FINAL DRAINAGE LETTER FOR LOT 3 OF CLAREMONT BUSINESS PARK 2 FILING NO. 1

Project #44-037
PCD – SP 20-000

RE: Drainage Letter for Lot 3 of Claremont Business Park 2 Filing No. 1

TRIANGULAR GRASSLINED CHANNEL
NTS

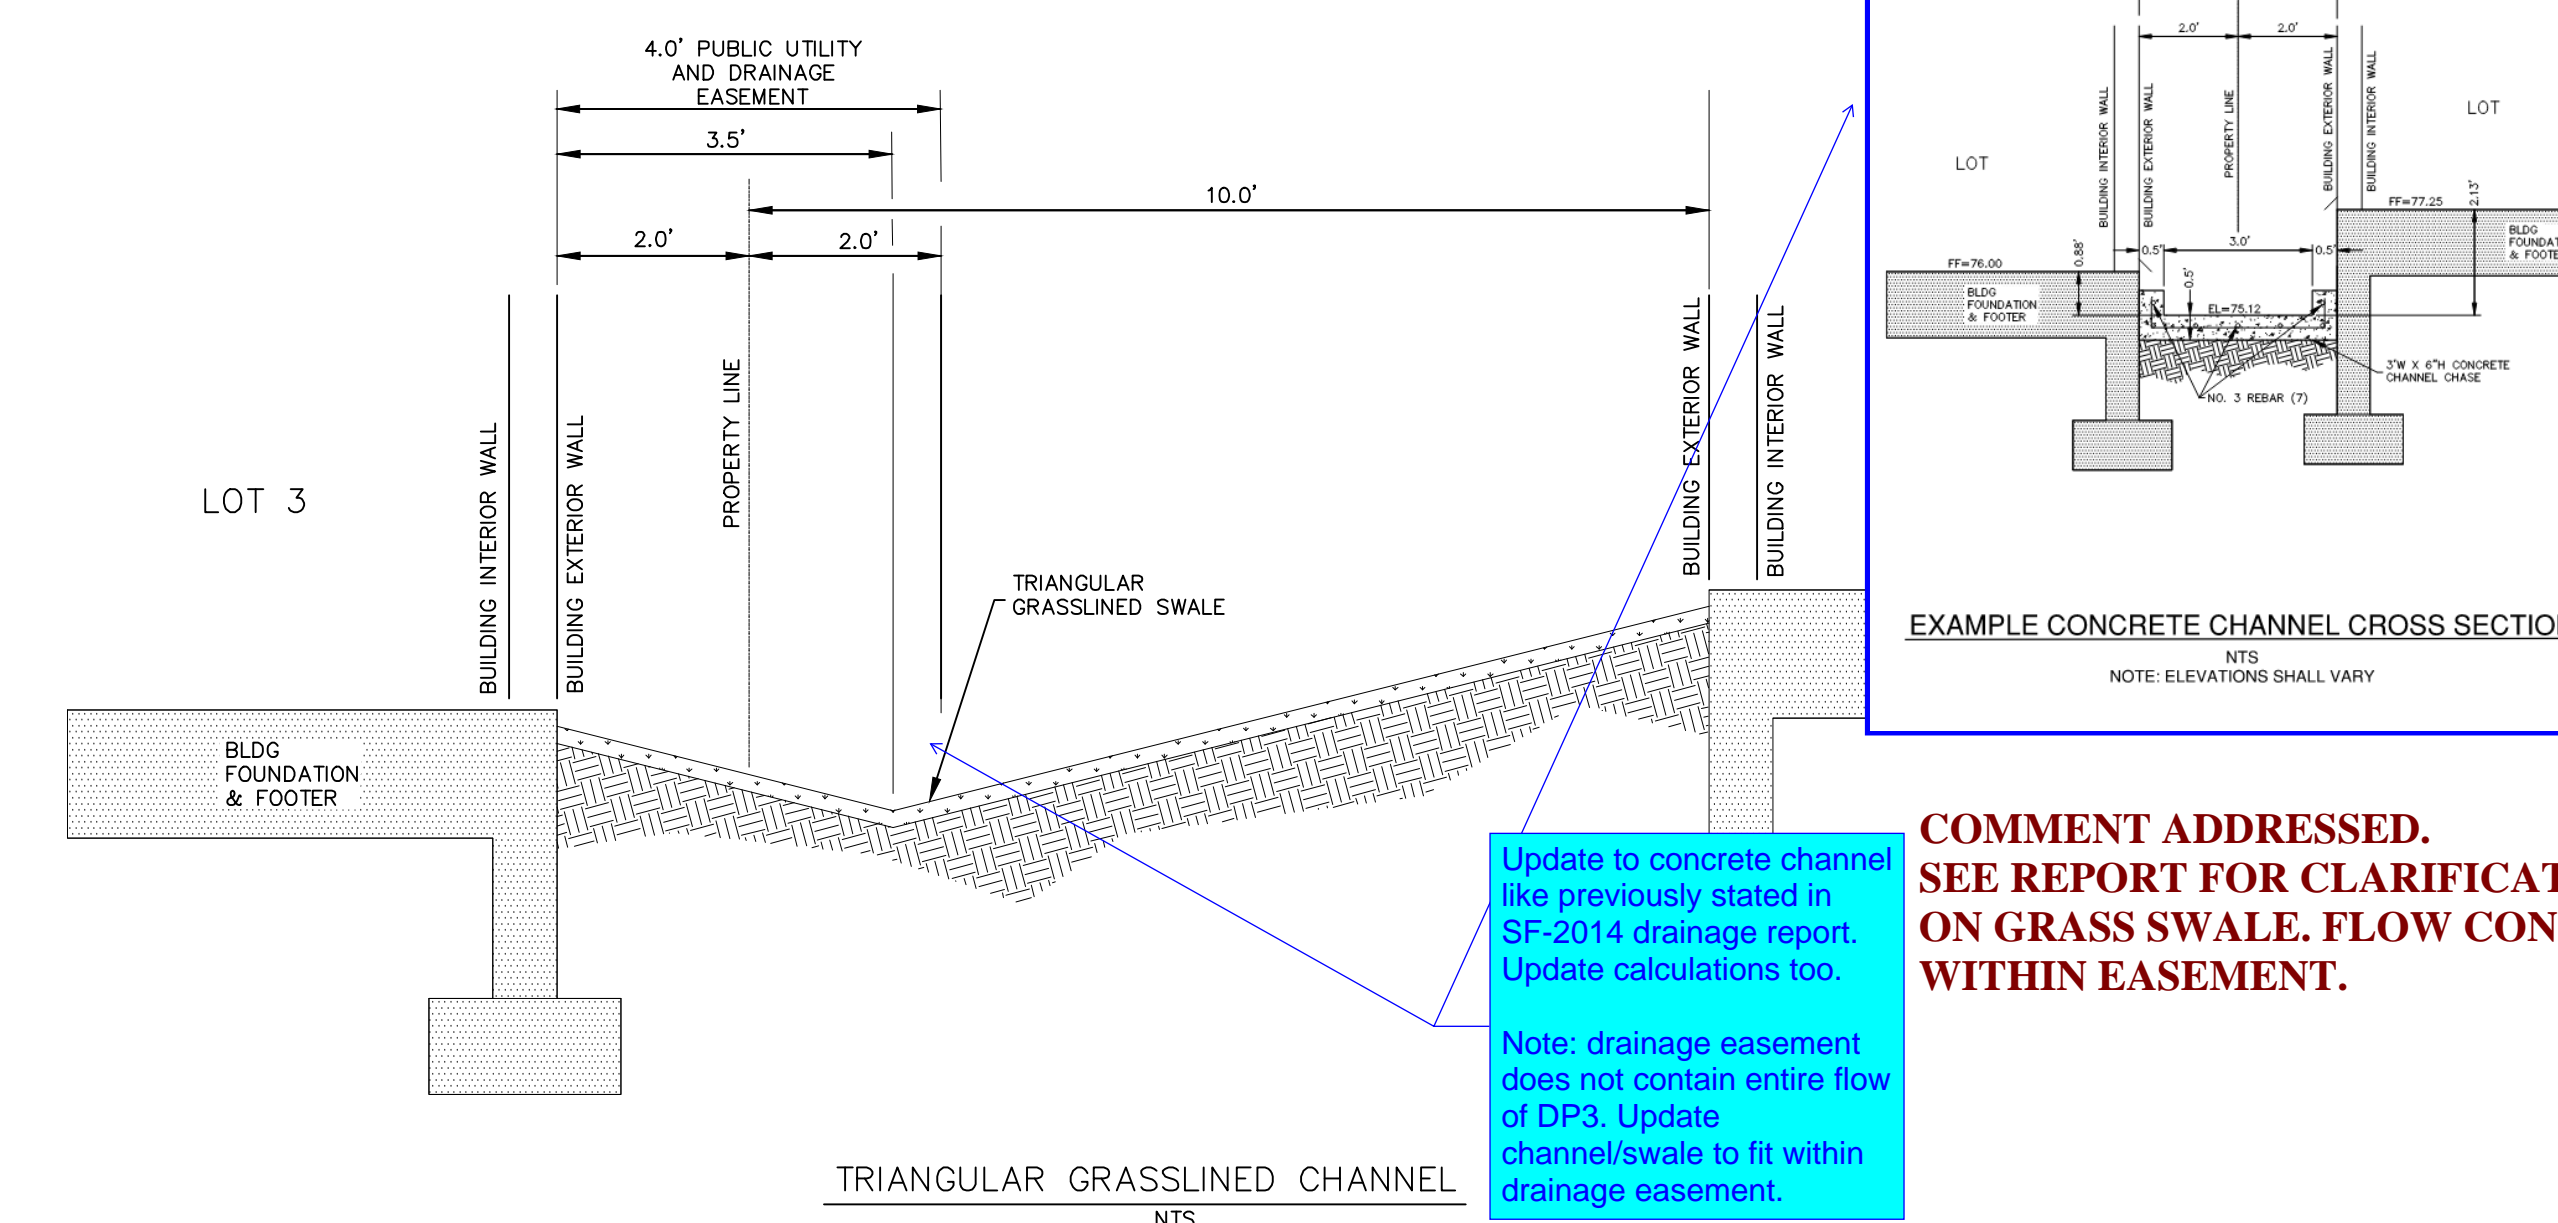
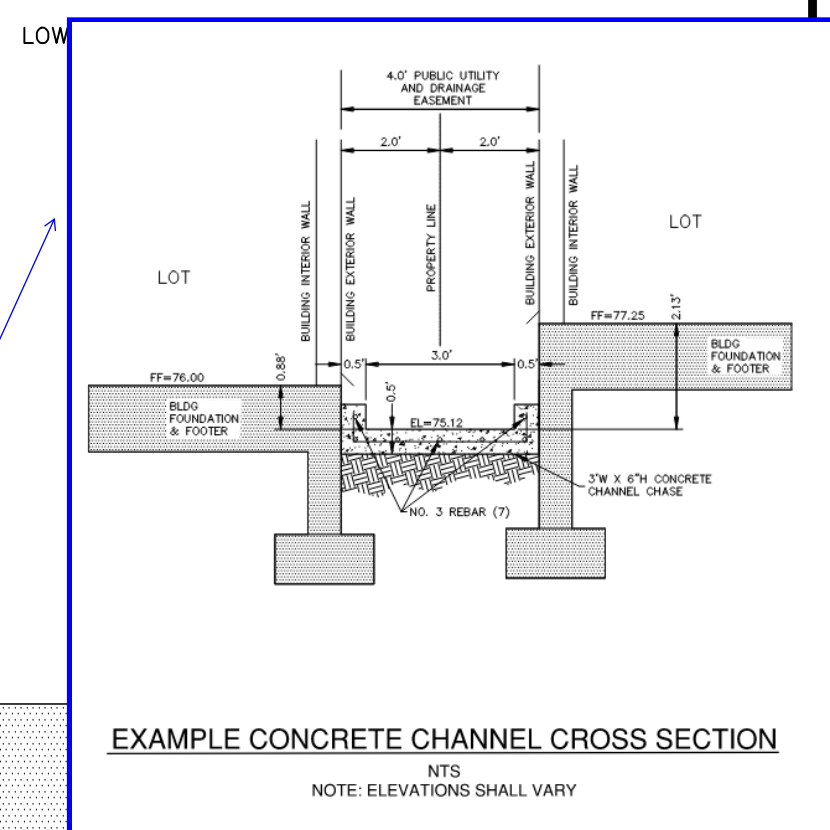
This is meant to be a concrete channel per SF-2014 drainage report. Revise to be in compliance with original report, or redesign grass swale to have water levels within drainage easement.

Update plans to
provide a dimension
of length for the
rundown.

Note: drainage easement does not contain entire flow of DP3. Update channel/swale to fit within drainage easement.

COMMENT ADDRESSED.
SEE REPORT FOR CLARIFICATION
ON GRASS SWALE.

COMMENT ADDRESSED.
DIMENSION INCLUDED.

COMMENT ADDRESSED.
SEE REPORT FOR CLARIFICATION
ON GRASS SWALE. FLOW CONTAINED
WITHIN EASEMENT.
